1150 Eastlake Ave E

SDCI Project # 3026536

Design Review Board Recommendation

West Design Review Board
March 13, 2019

West Facade

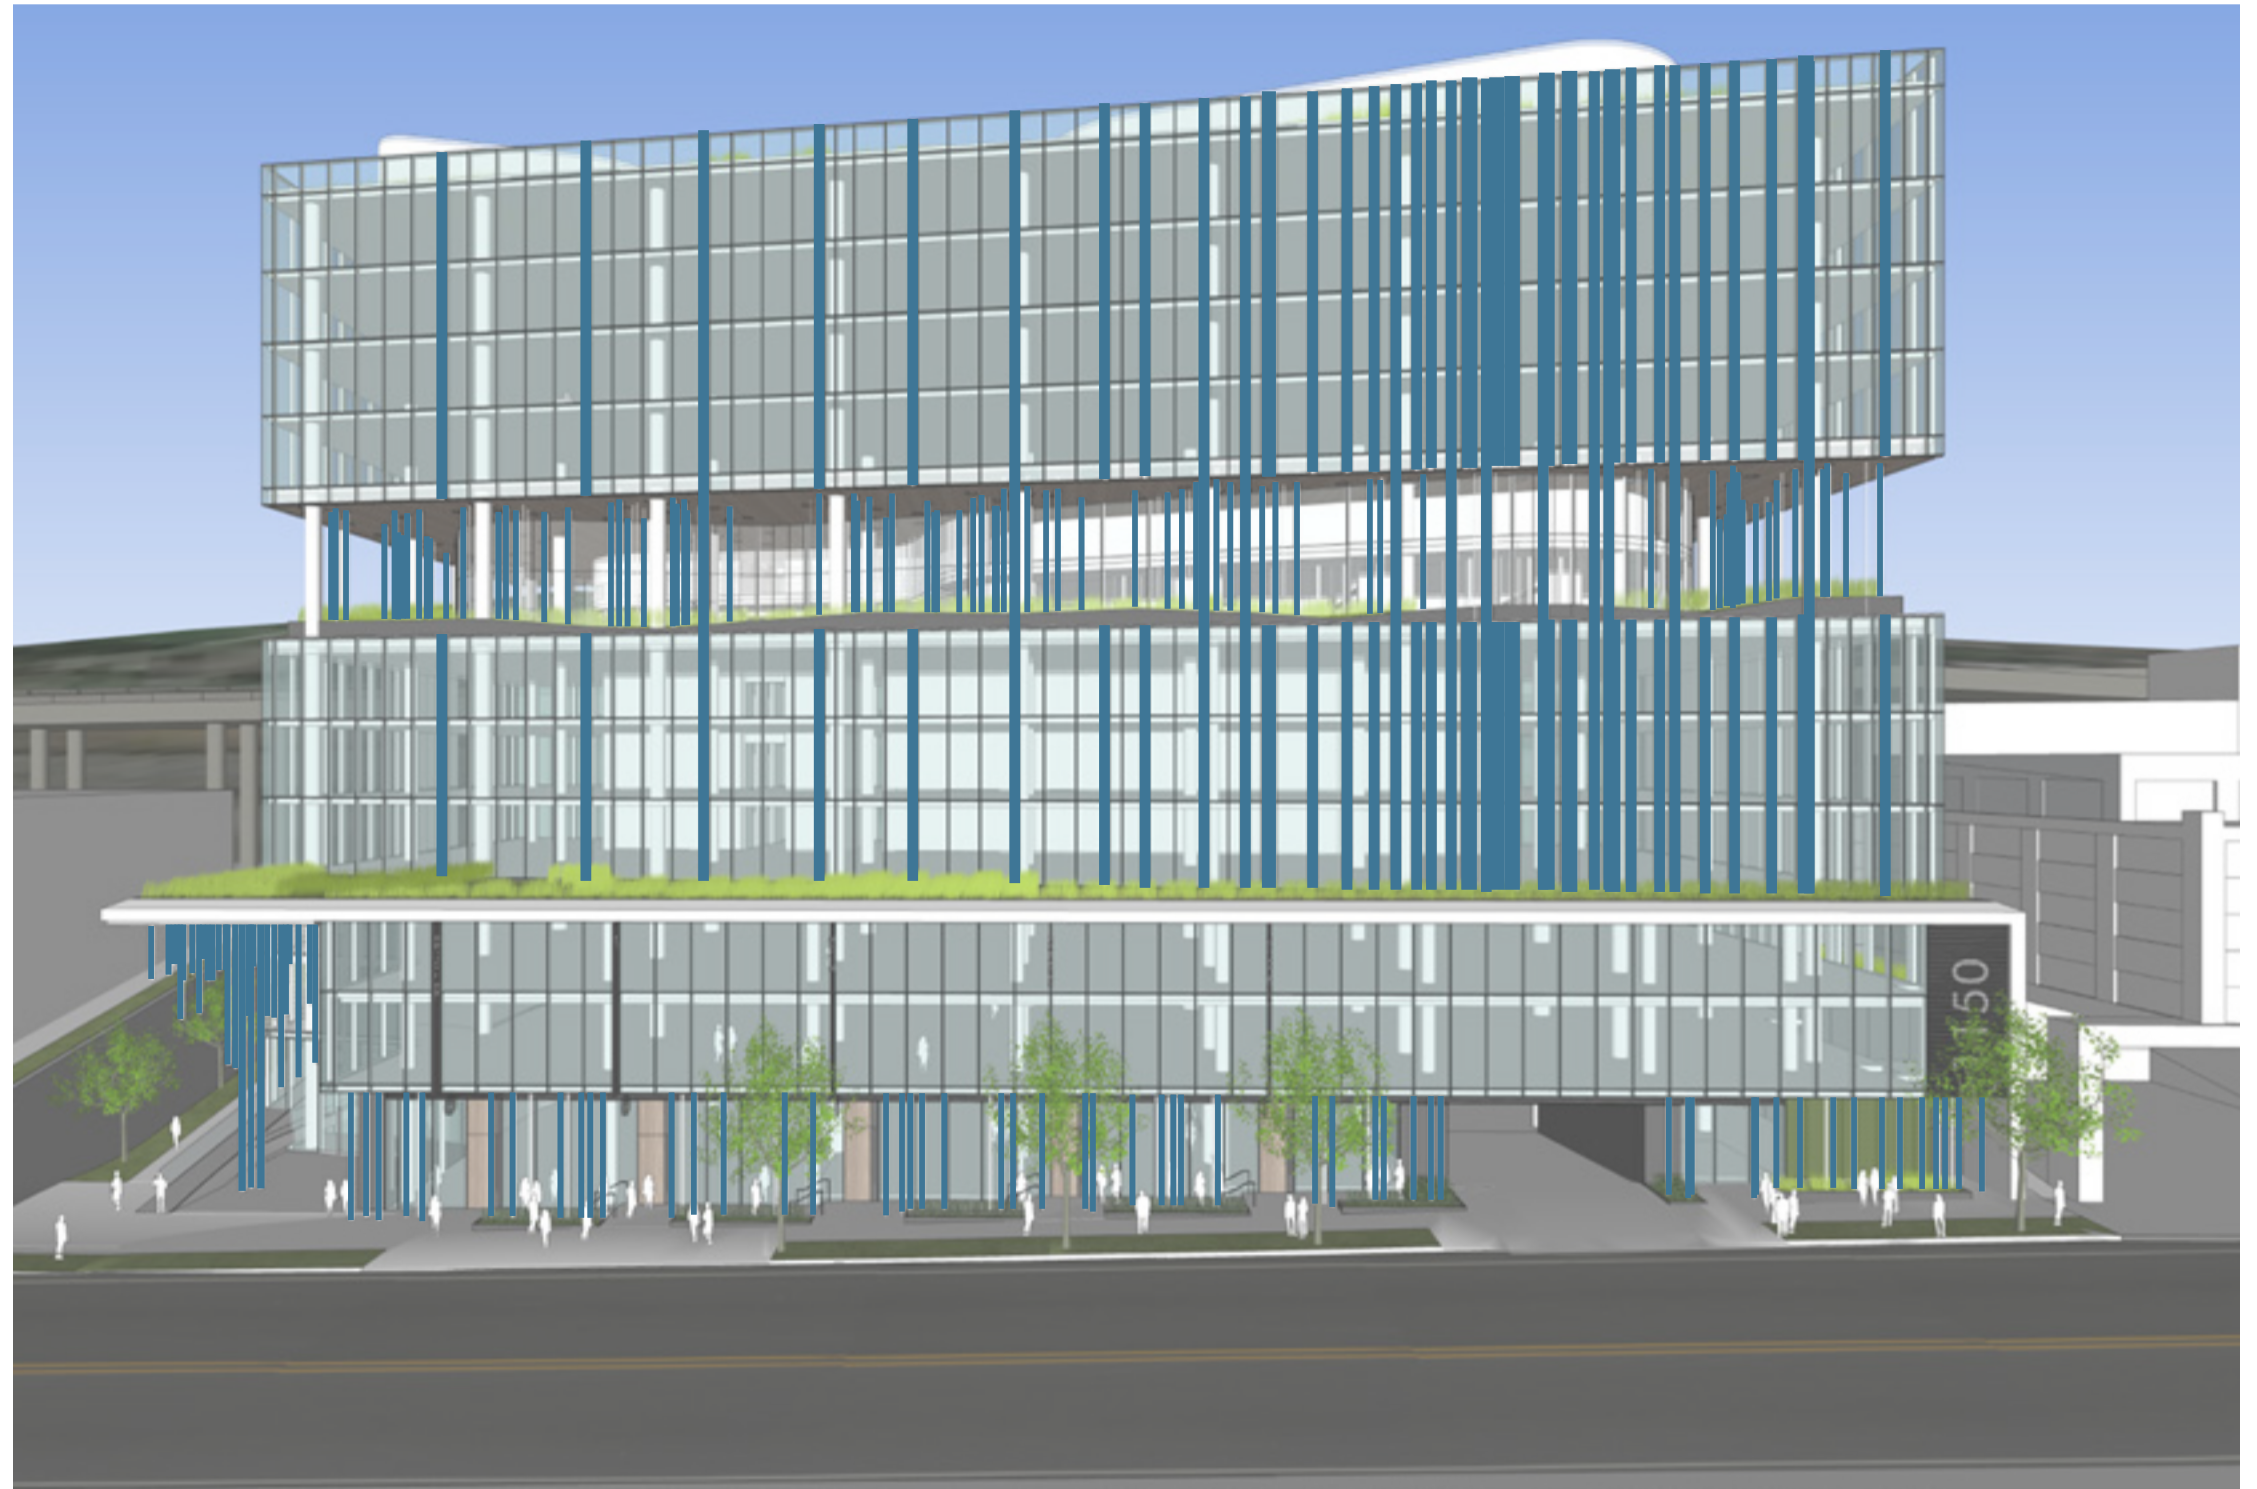
“The board thought that more verticality could be expressed on the building facades to support and organize the forest concept.”

The vertical façade fins are organized into a pattern that’s inspired by the water wakes on the lake in a manner that increases verticality as the wake progresses and recedes on each façade.

- Spacing of vertical elements drawing from proportions of Steam Plant
- Additional vertical tubes placed close to the façade on the upper level “break”, deepen and densify the forest concept
- Sculpture tubes at main entry plaza brings verticality of Wake and Forest to grade
- Vertical thrust of the Forest is carried along the galleria on Eastlake Ave. E

Street Level Plan

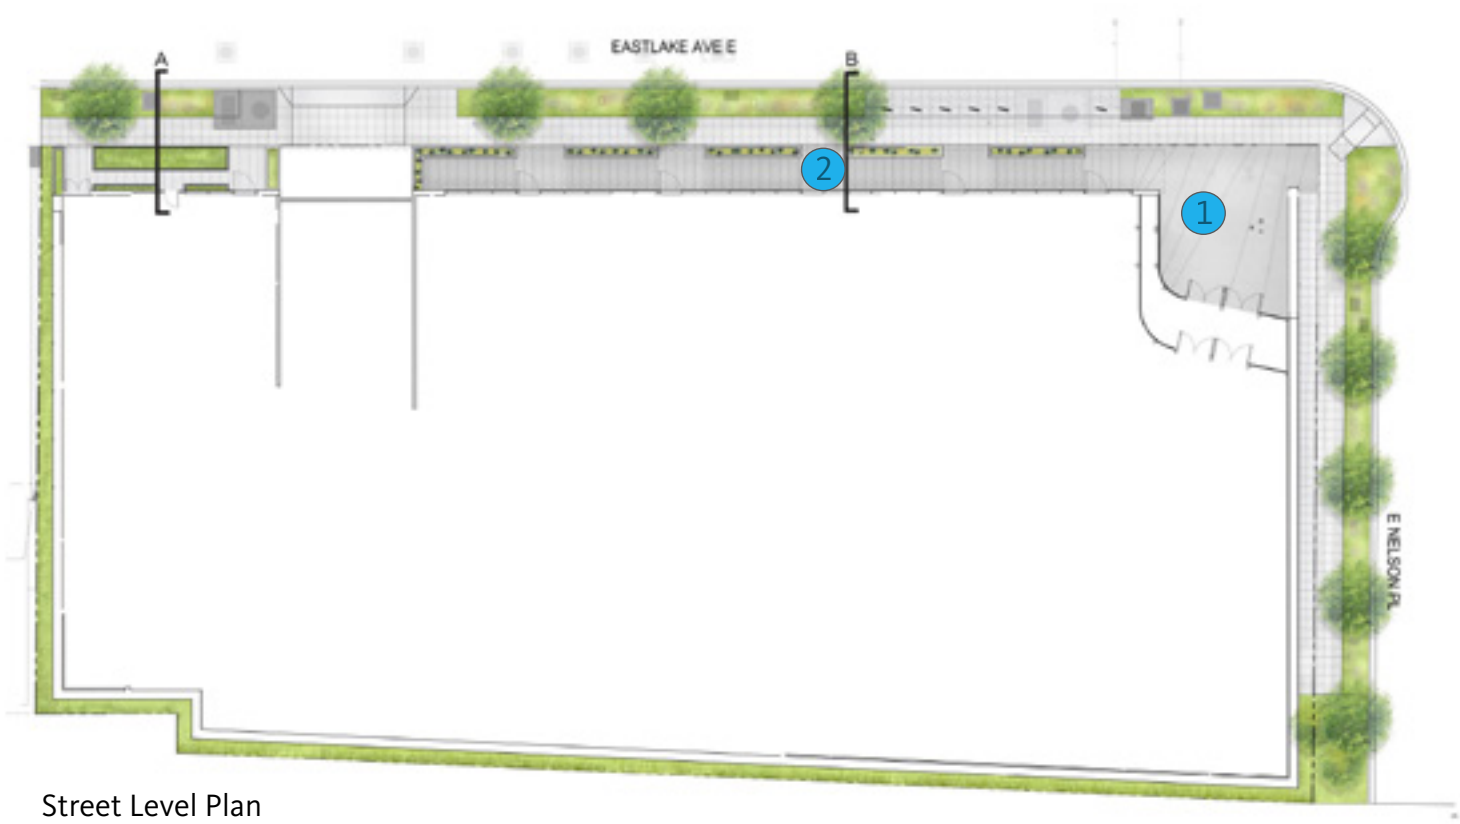
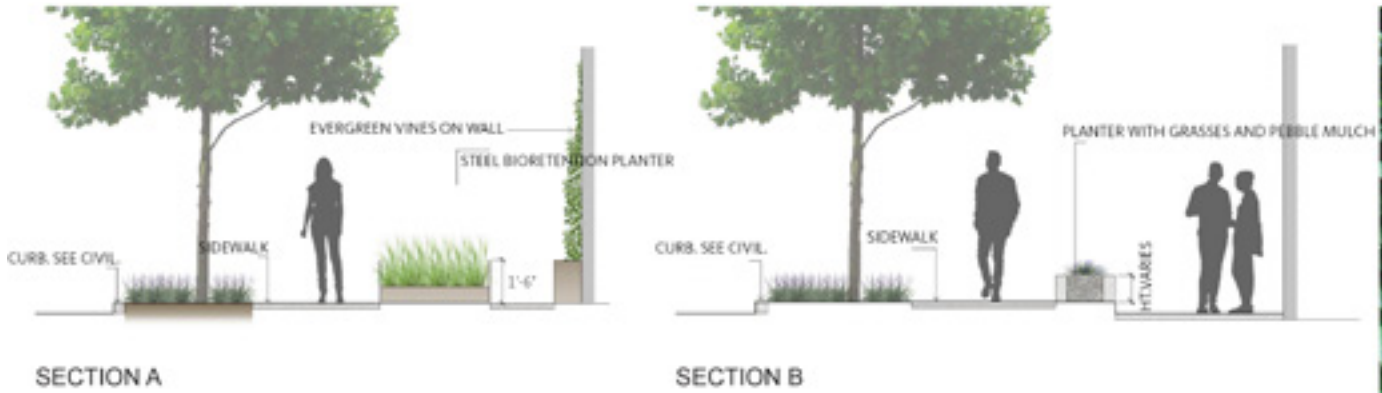
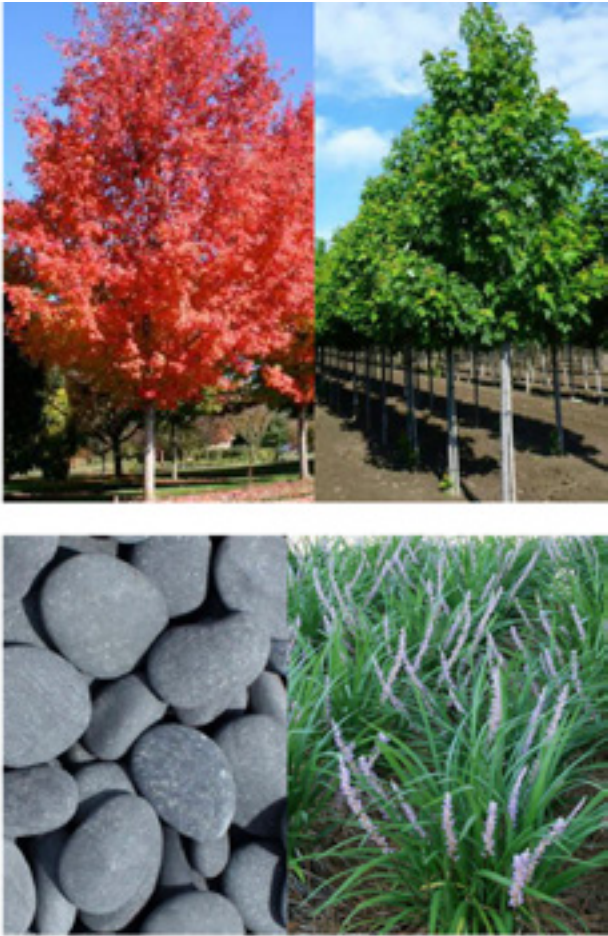
“The Board recognized and appreciated the landscape concepts of forest and water, and the concept should be more fully developed at the ground level and should serve to connect the sidewalk and interior spaces.”

The landscape plan at ground level is developed as a highly porous connection between the public realm and the building’s entrances.

- Trees and planting bring the Forest to the street
- Planters and columns organized to ease pedestrian flow
- Paving and plants positioned for wayfinding to entries and enhancing the experience within the colonnade

Level 7 Axon

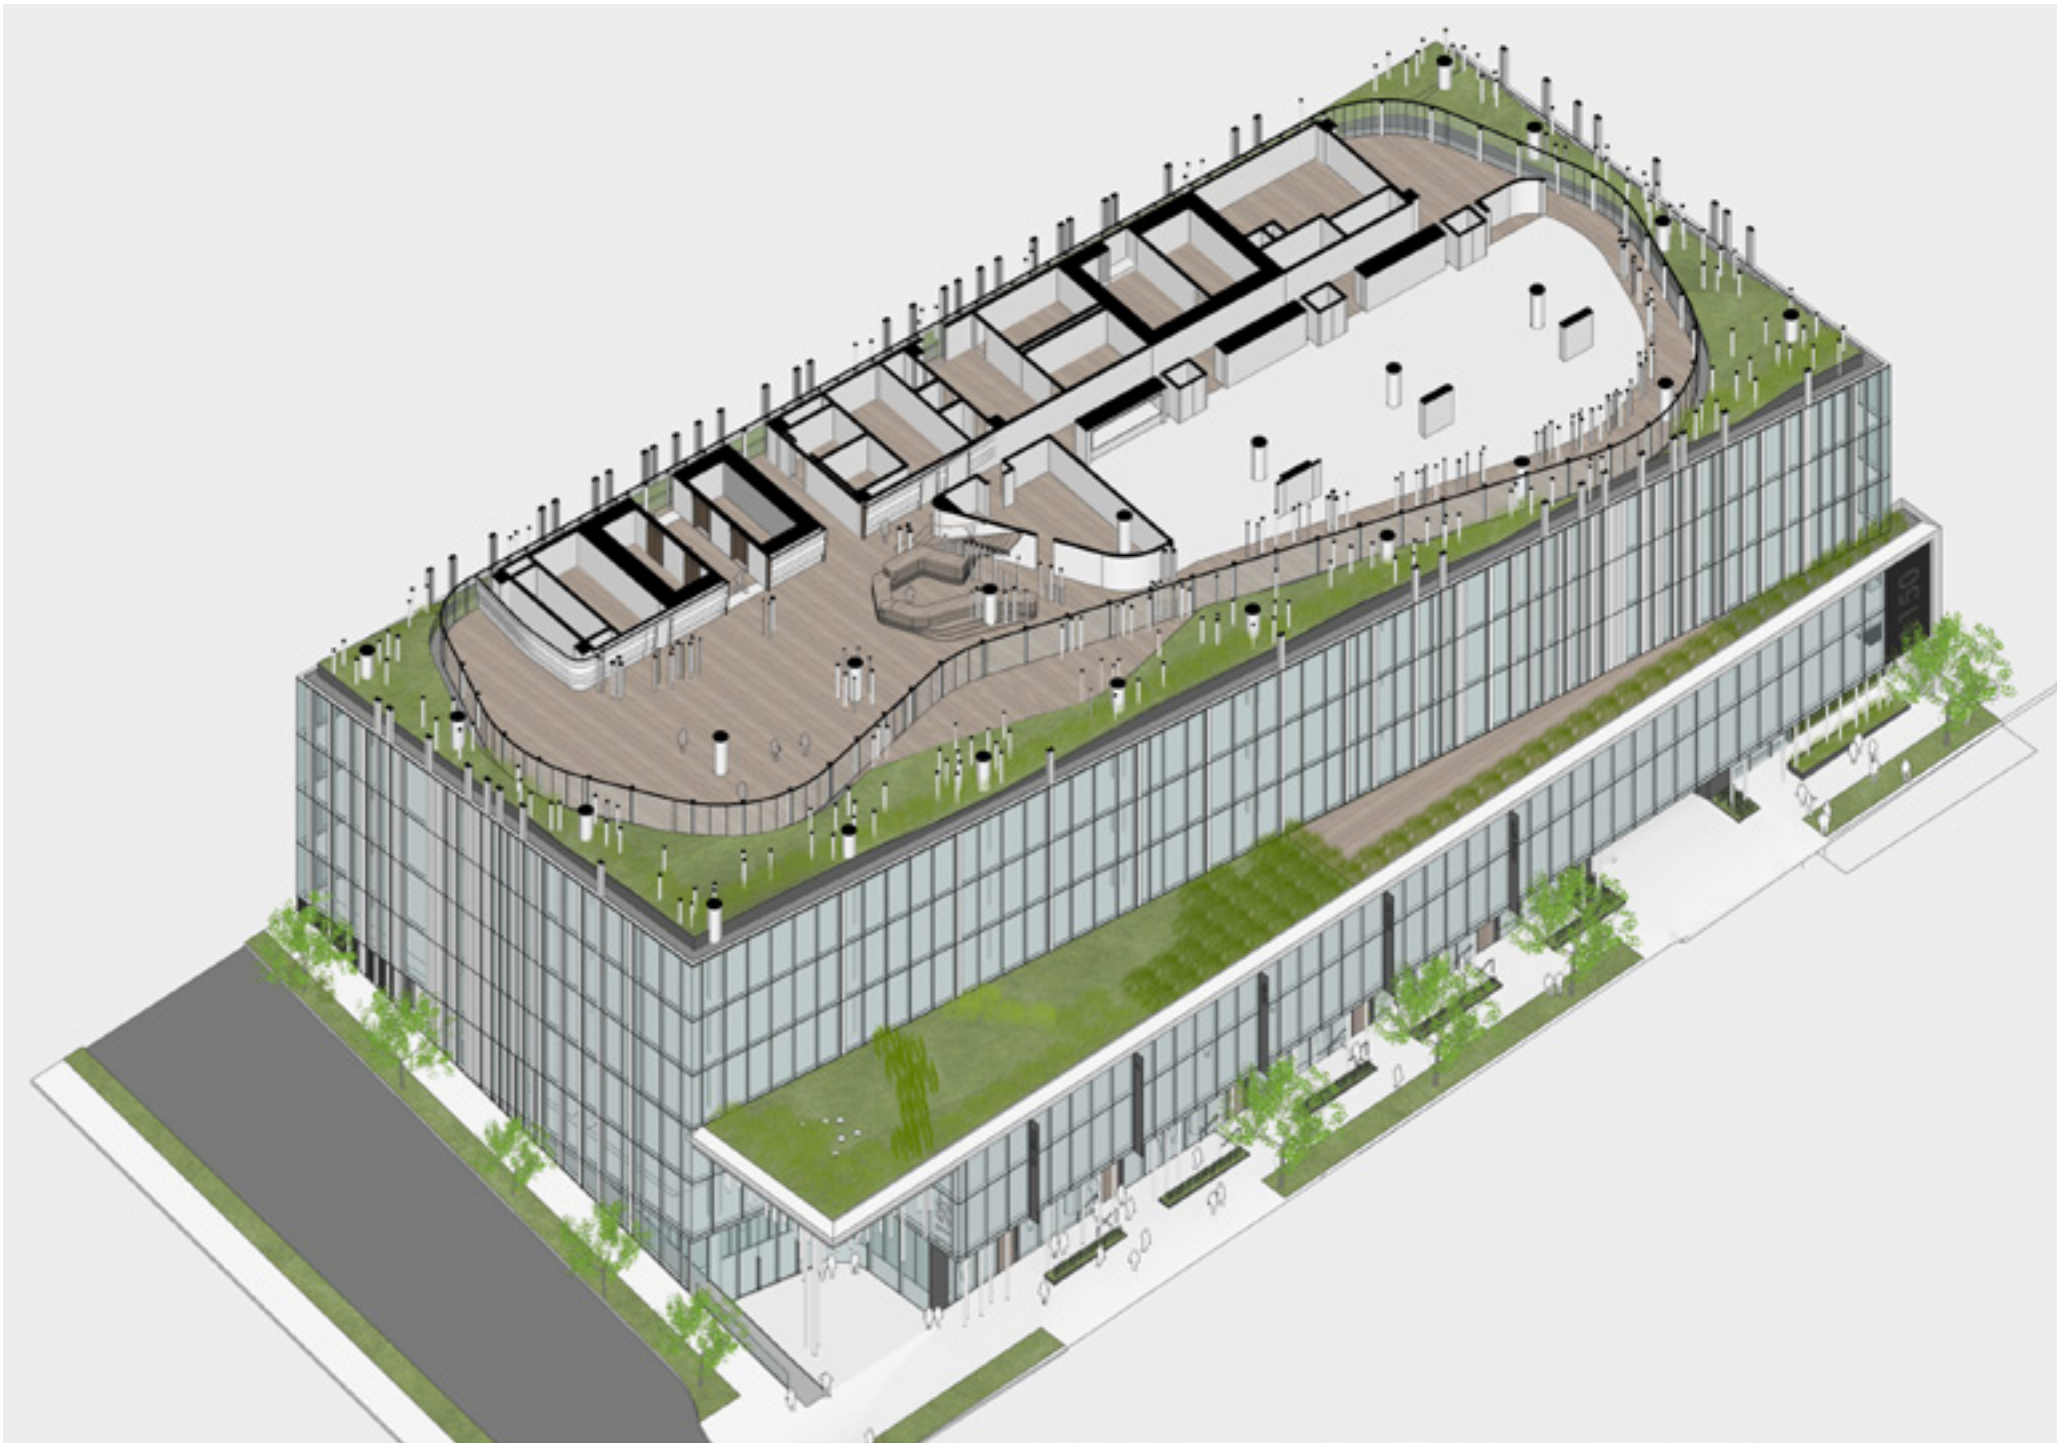
“The Board supported the midlevel open space where the landscape elements reinforce the forest and water concepts.”

The mid-level break is where the forest is fully realized in an abstract way, combining the colonnade introduced at the grade level, the sculptural feature at the entry plaza and the greenscape from the top of the podium.

- Unsustainable green vertical elements removed
- Supplemental, more densely placed slender columns invoke varying textures of the Forest across a lushly planted and sculpted ground plane.
- Amplified in a richer, more 3 dimensional texture that casts playful shadows against the undulating glass backdrop.
- Lighting program brings Forest to life after dark
